Informal document GRSP-70-18
70th GRSP, 6-10 Dec. 2021,
agenda item 11

Modification of R16/R129 Support Leg Volume

Submitted by the experts from CLEPA

JUSTIFICATION (1/6)

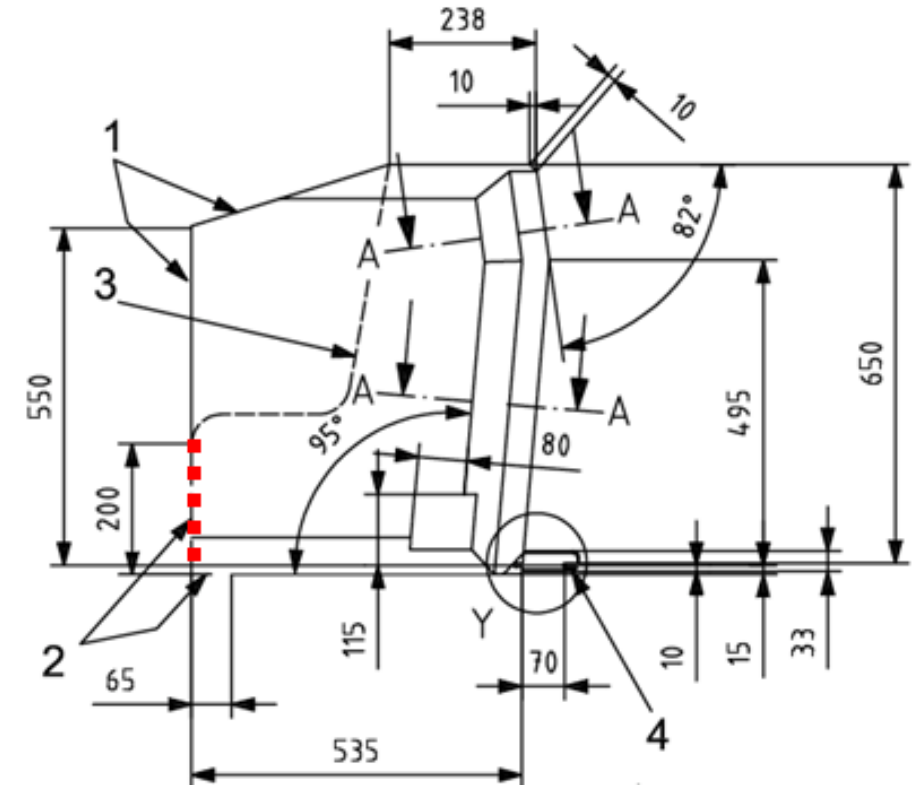
- UN Regulation No. 16 defines the envelope dimensions of ISO/R2 & ISO/F2X CRF envelopes
 - Dashed line 2) represents the area where a support leg or similar may protrude. For the ISO/F2X envelope, this is indicated with a height of 200 mm (red dotted line)
- The proposal is to increase the support leg volume height to match this 200 mm dimension

JUSTIFICATION (3/6)

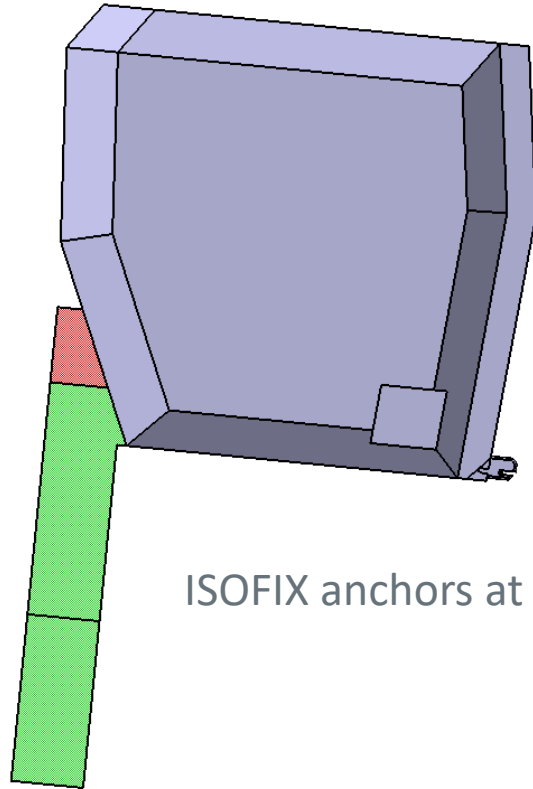
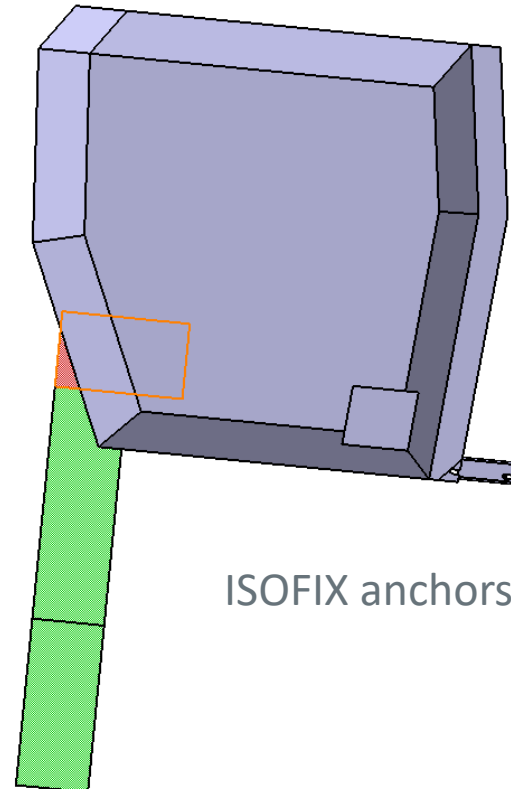
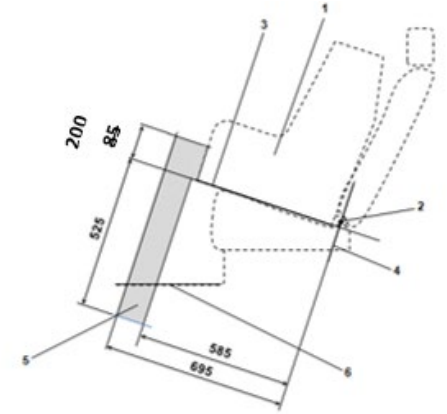
- The additional support leg volume already overlaps with the ISO/R2 volume and therefore little or no extra space is required (depending on ISOFIX position)

JUSTIFICATION (4/6)

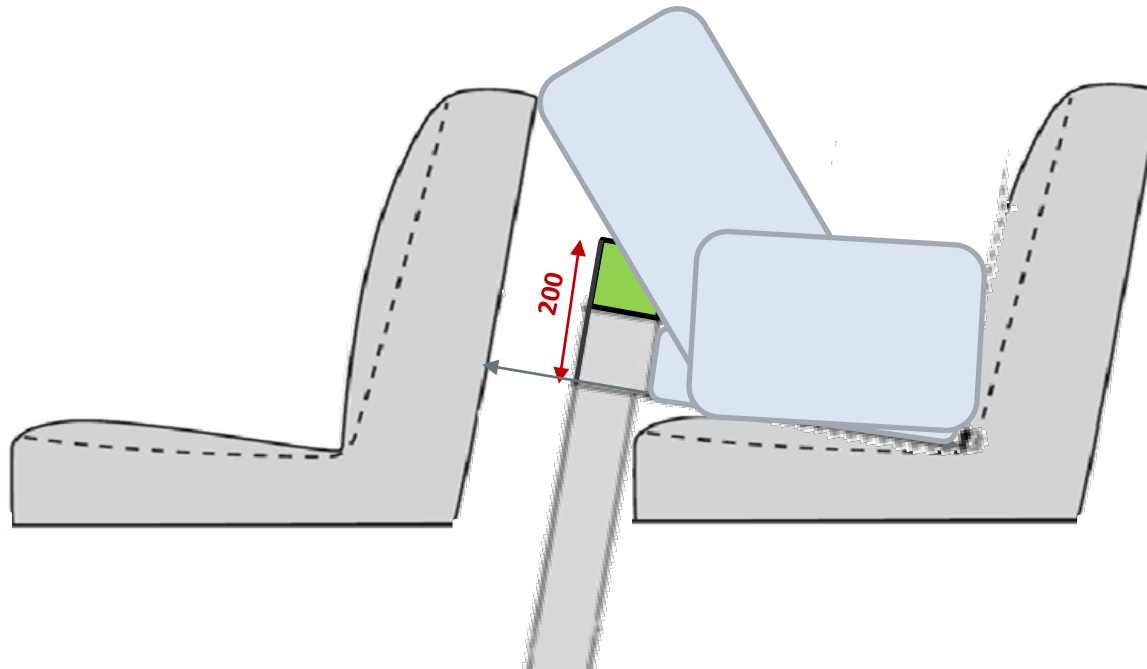
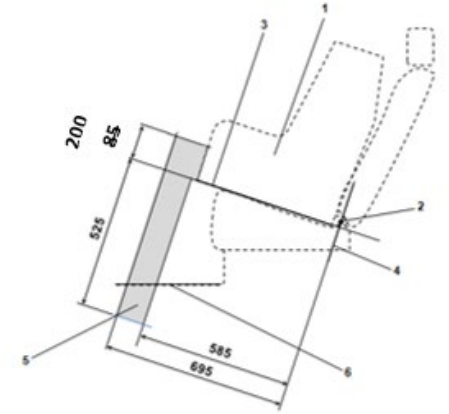
- The additional space required by extending the support leg volume is available in vehicles that can already fit the support leg volume
- This additional support leg volume unused in the vehicle (100 vehicles)
- If contact between the child seats and vehicle seat occurs, it is at the top of the seat, not where the additional support leg volume would be

JUSTIFICATION (5/6)

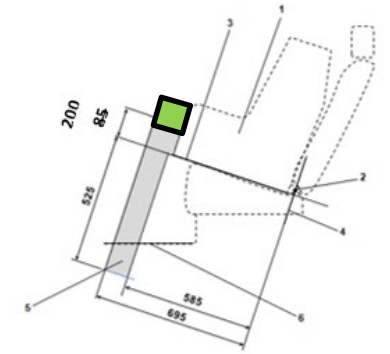
- Additional support leg volume unused in the vehicle
- Vehicle contact between child seats and vehicle seat occur at the top of the seat
- Examples (Small Off-Road)

JUSTIFICATION (6/6)

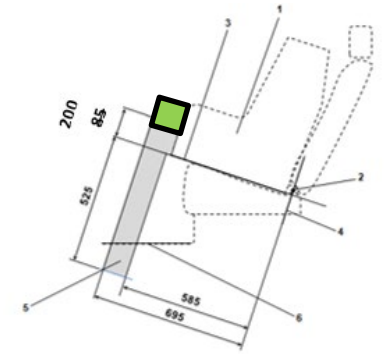
- Additional support leg volume unused in the vehicle
- Vehicle contact between child seats and vehicle seat occur at the top of the seat
- Examples (Supermini)
